**STATE OF TENNESSEE
DEPARTMENT OF TRANSPORTATION**

INSTRUCTIONAL BULLETIN NO. 21-20

Regarding Various Revised, New and Voided Standard Drawings

Effective May 13, 2022 letting (March 2, 2022 Turn-in), the following Standard Drawings have been revised or are new. In addition, the Roadway Design Guidelines Chapter 7 – Item Numbers, Sections 7-611.00, Manholes, Catchbasins, Inlets and Pipe End Walls, and Section 7-705.00, Guardrails, of the Roadway Design Guidelines has been modified to reflect any changes to or new item numbers in the Standard Drawings of this Instructional Bulletin.

DETAILS OF LOWERED STANDARD CONCRETE DRIVEWAYS

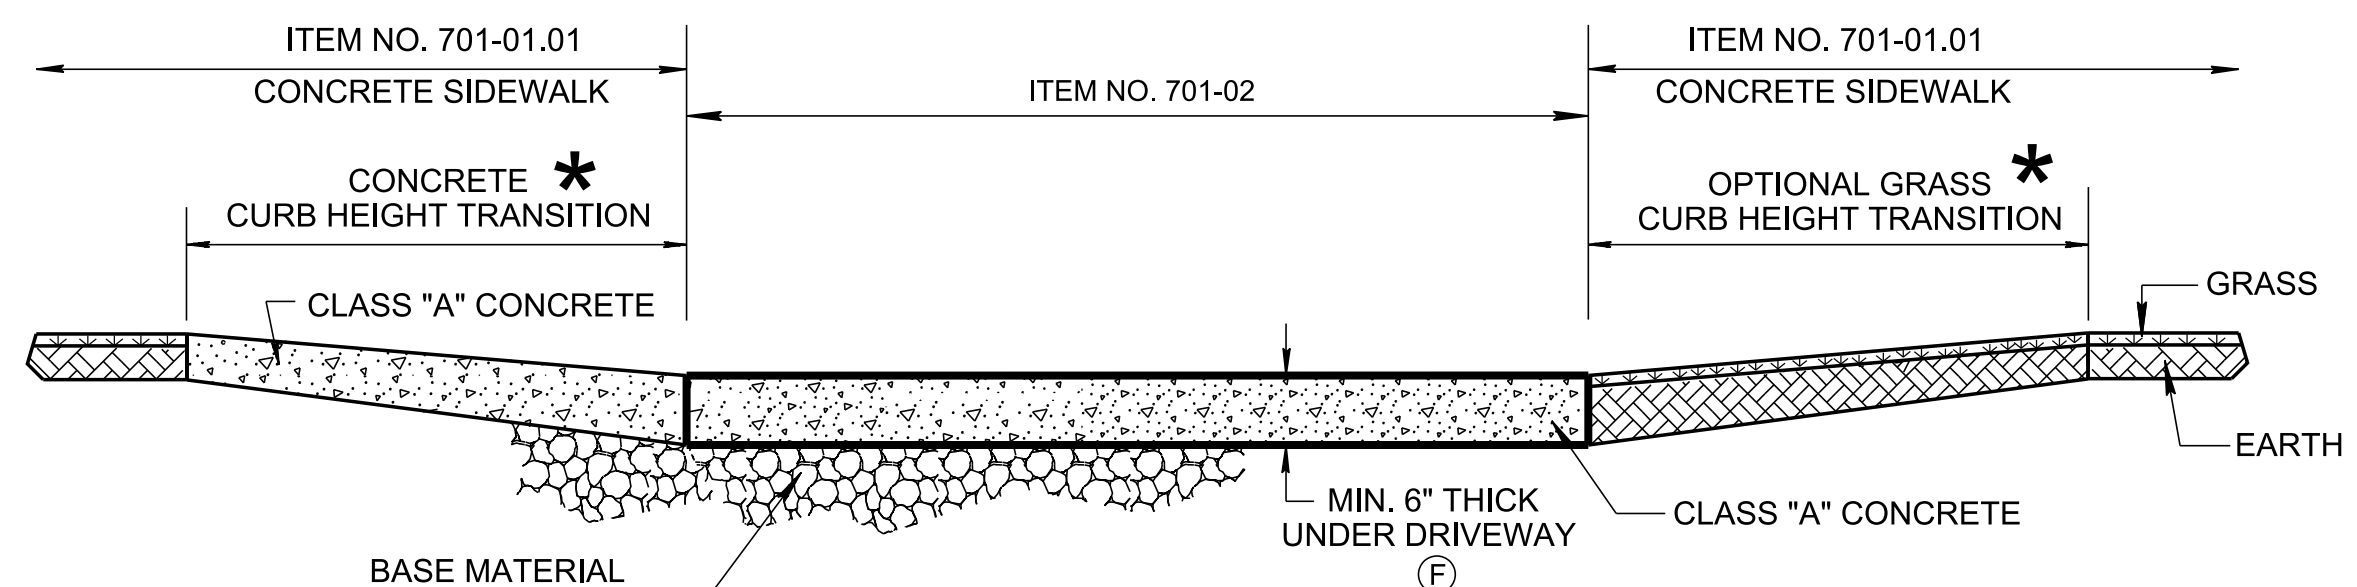
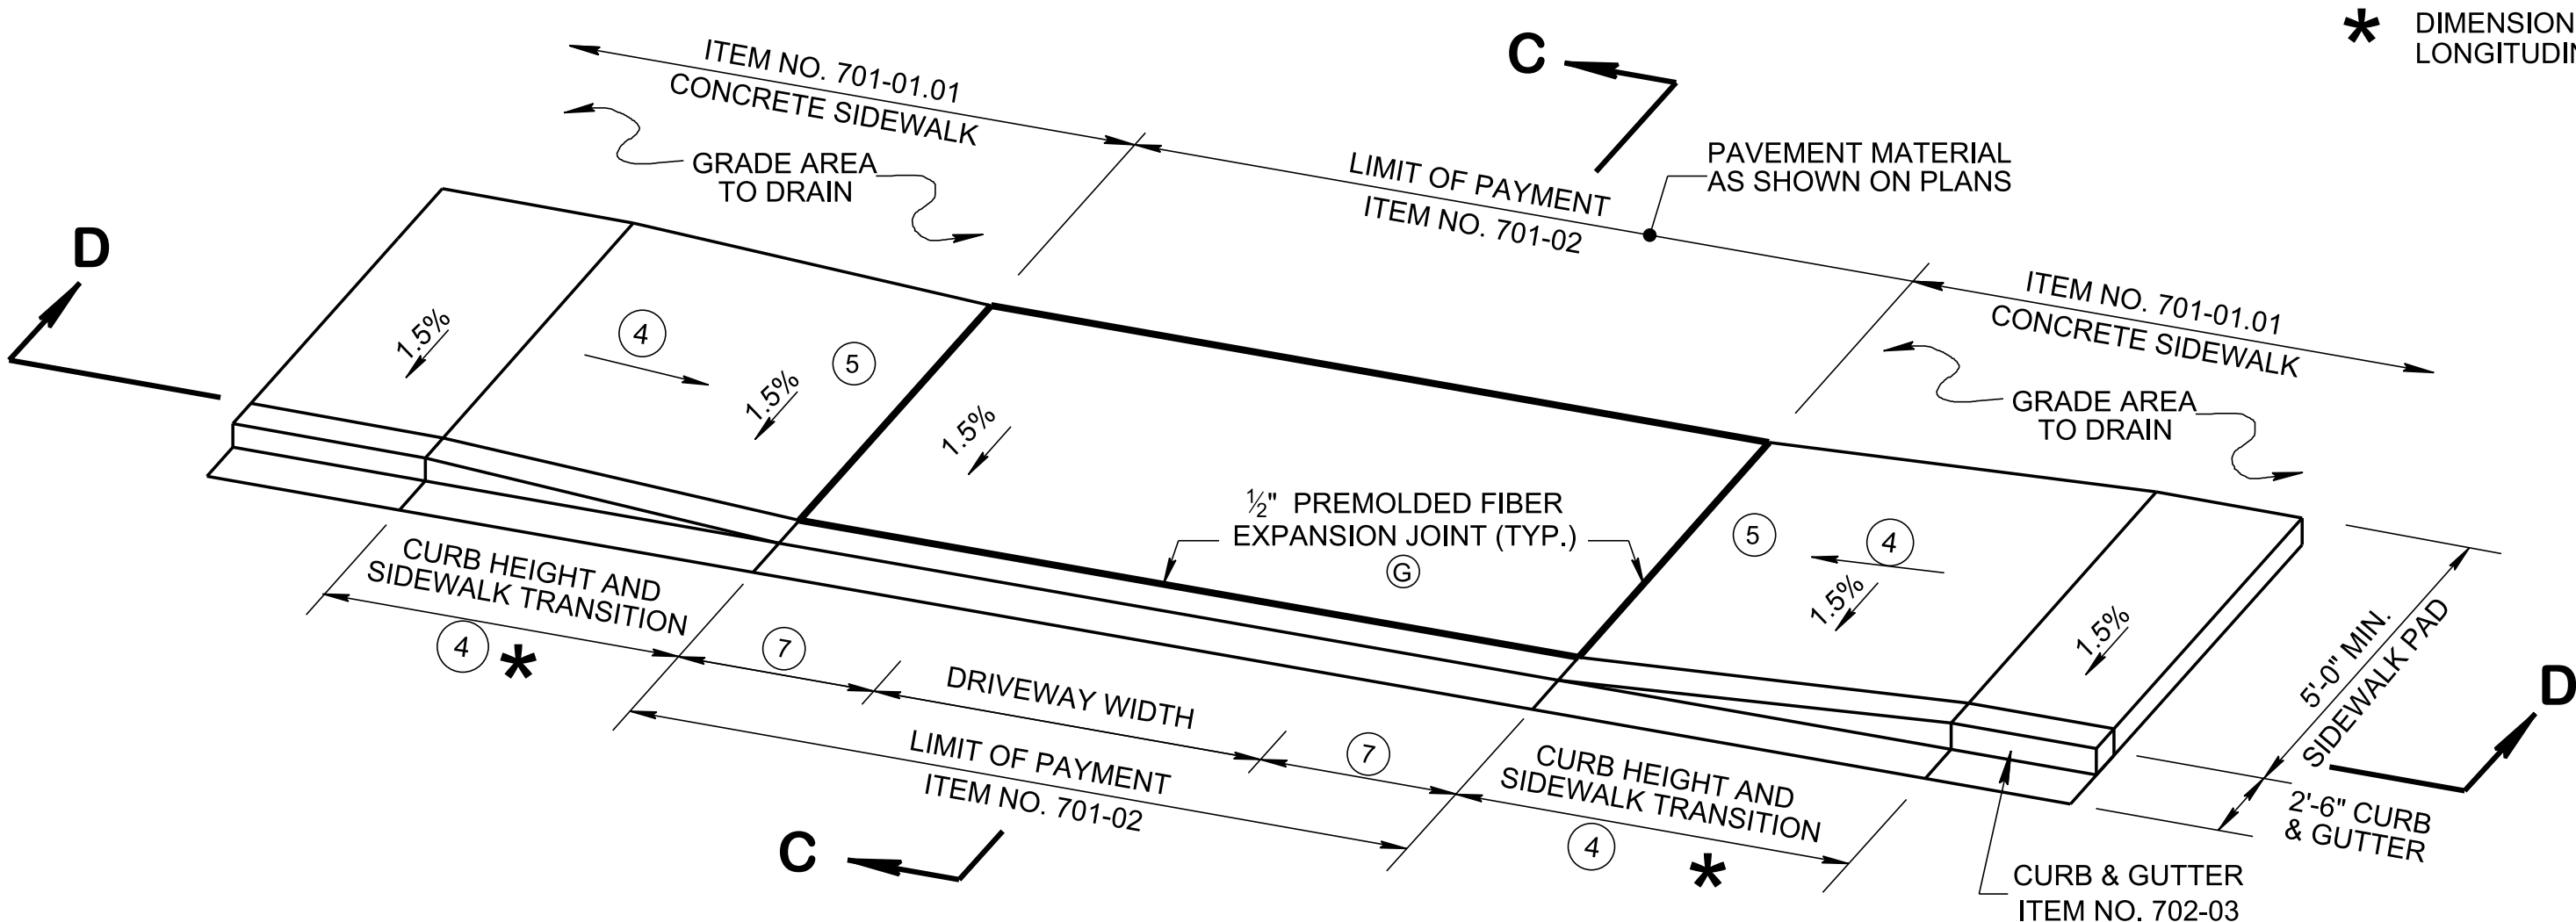
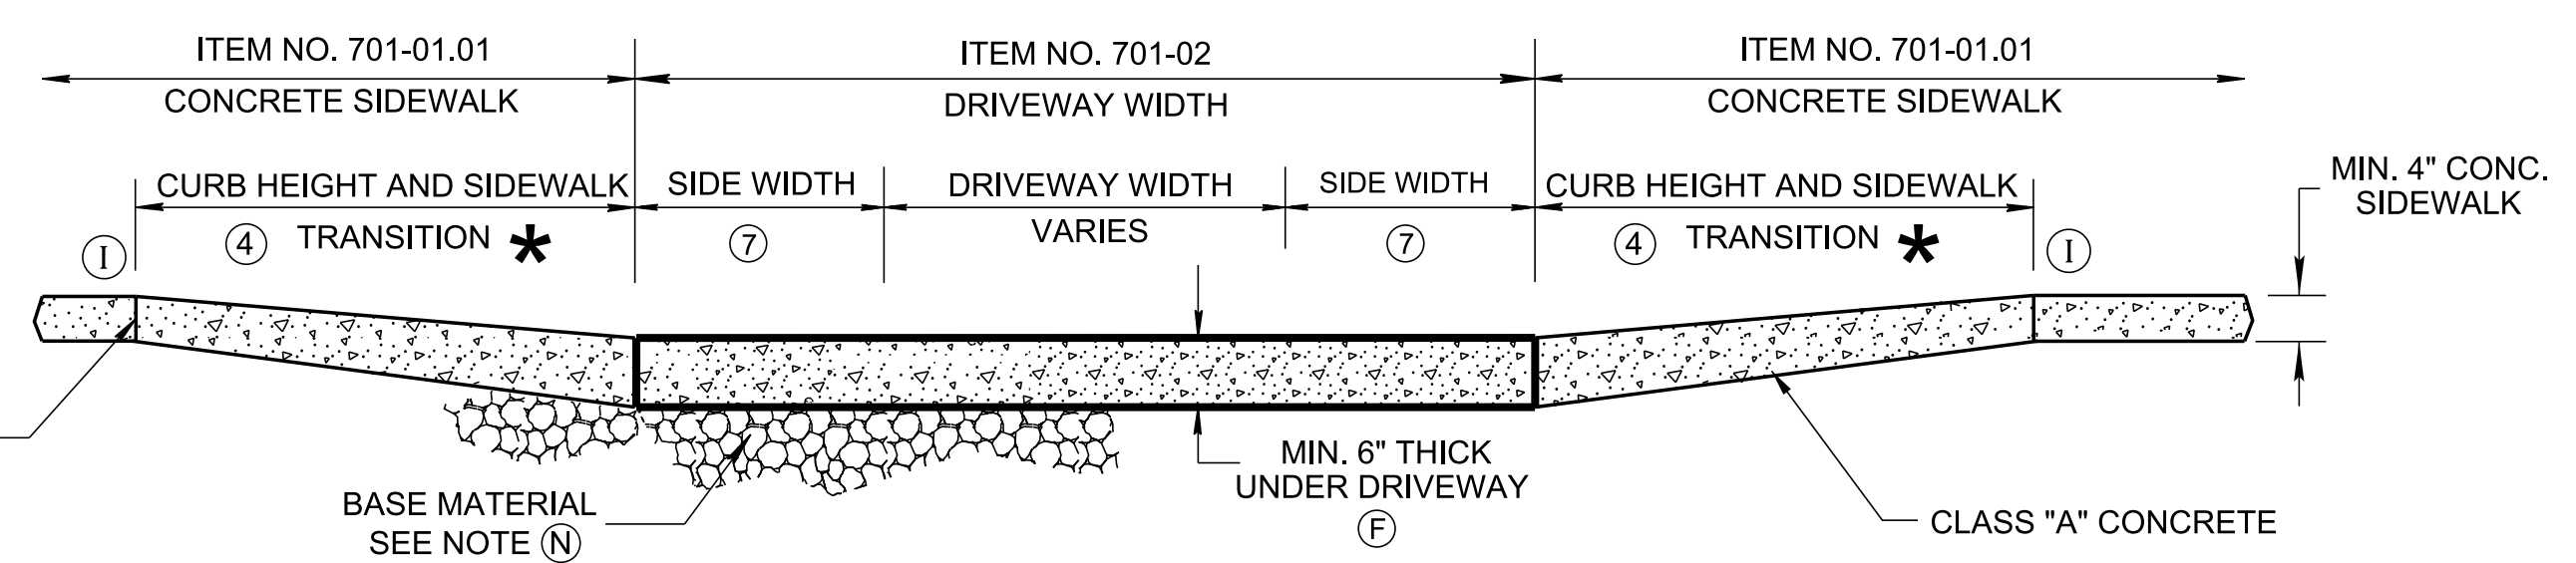
REV. 10-29-2021: FOOTNOTE NUMBER 7 WAS ADDED. SIDE WIDTH AND FOOTNOTE NUMBER 7 WERE ADDED ON TYPE C DRIVEWAY AND ON SECTION D-D.

CABLE BARRIER PLACEMENT

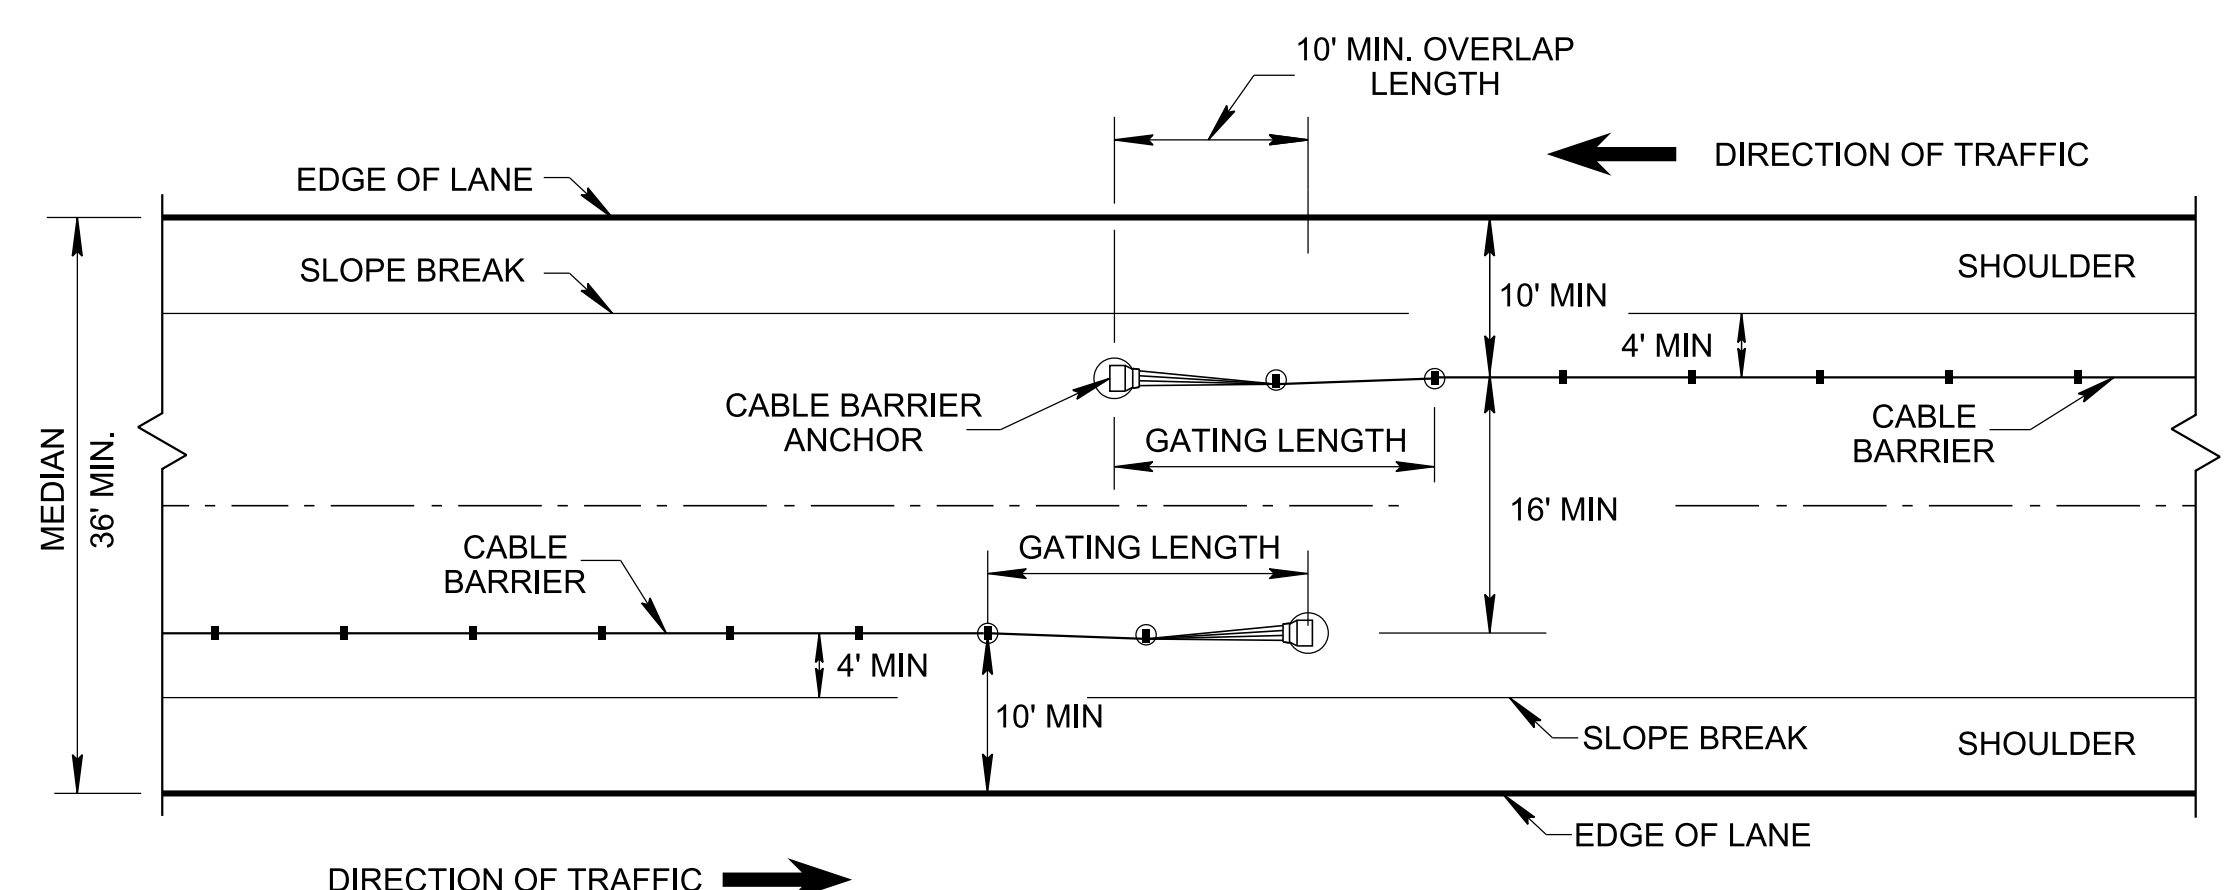
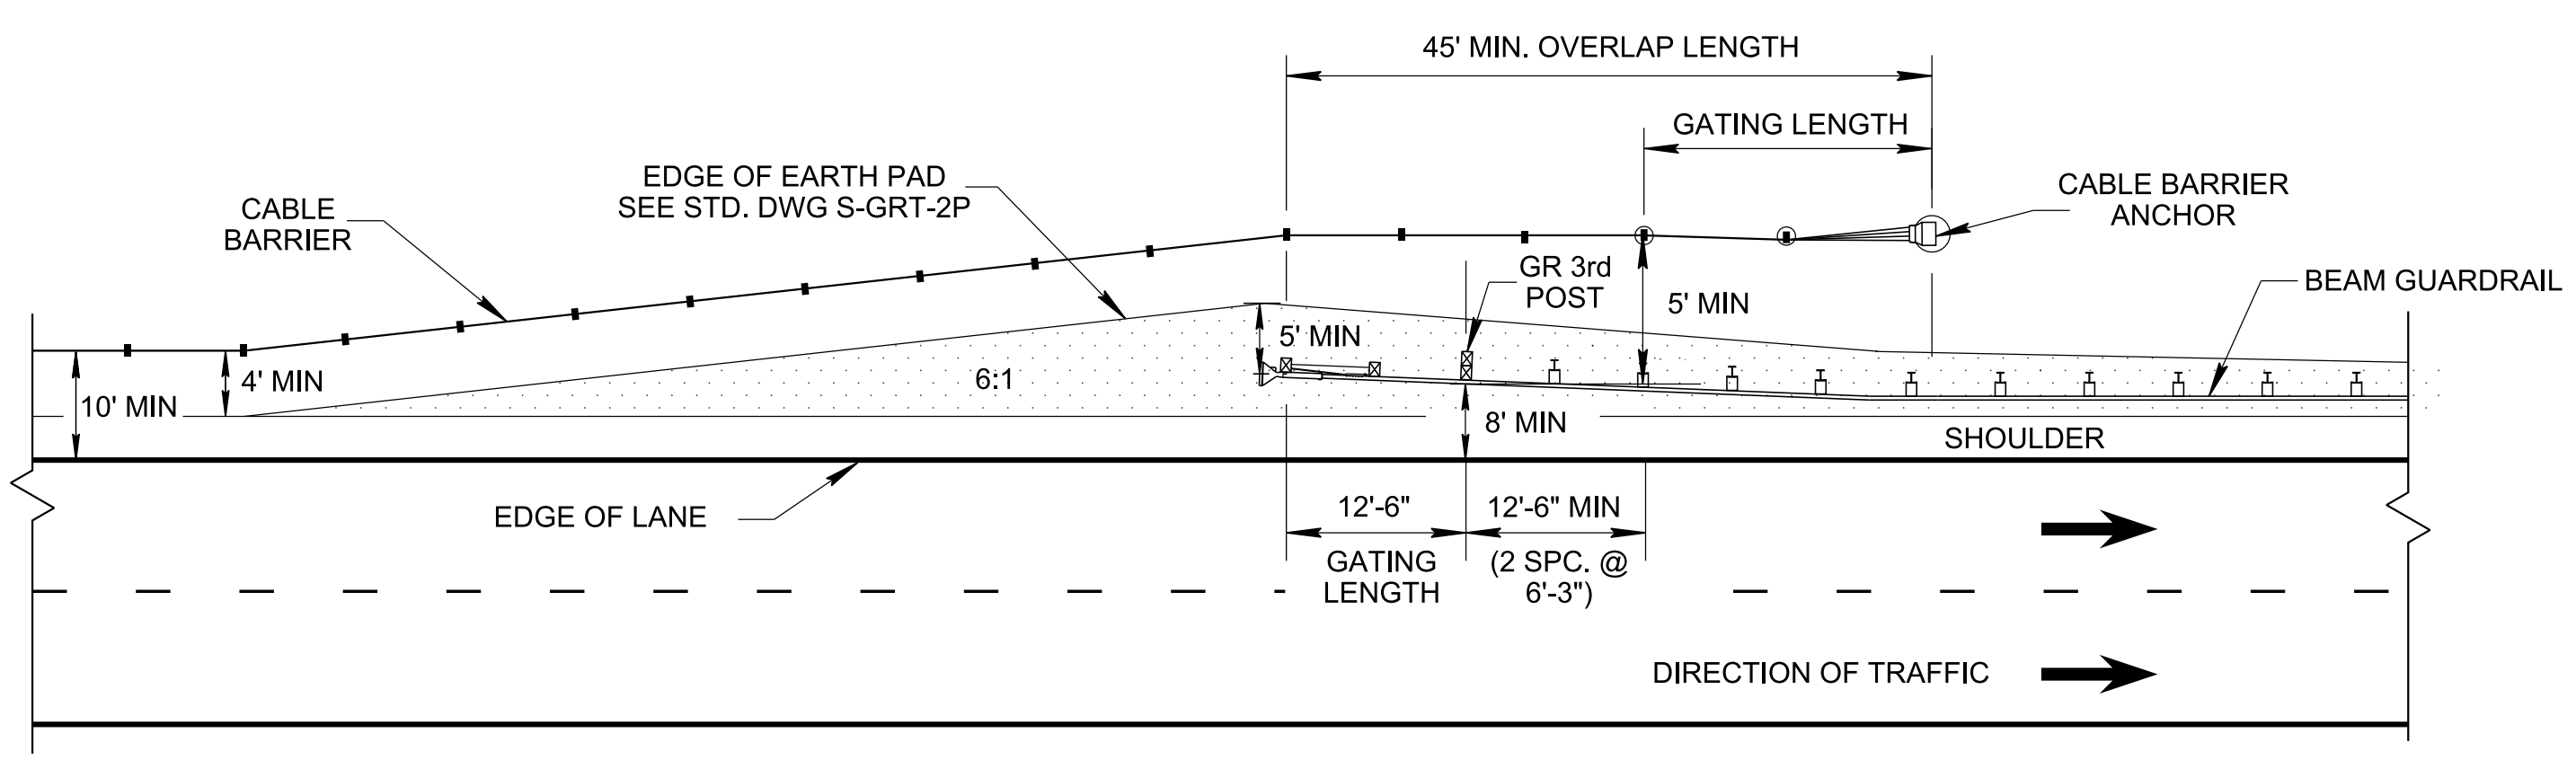
REV. 10-29-21: THE PLAN VIEW AND DETAILS B-1 AND B-2 WERE REMOVED. DETAIL A WAS REDRAWN AND DETAILS B AND C WERE ADDED. THE "TYPICAL PLACEMENT LOCATIONS FOR CABLE MEDIAN BARRIER" WAS REMOVED AND REPLACED WITH FOUR DETAILS. THE TABLE AND ASSOCIATED EQUATION AND NOTE WERE ADDED. ALL GENERAL NOTES WERE REVISED. ITEM NUMBERS 705-80.01 AND 705-80.03 WERE REMOVED. ITEM NUMBERS 705-06.50 AND 705-06.51 WERE ADDED.
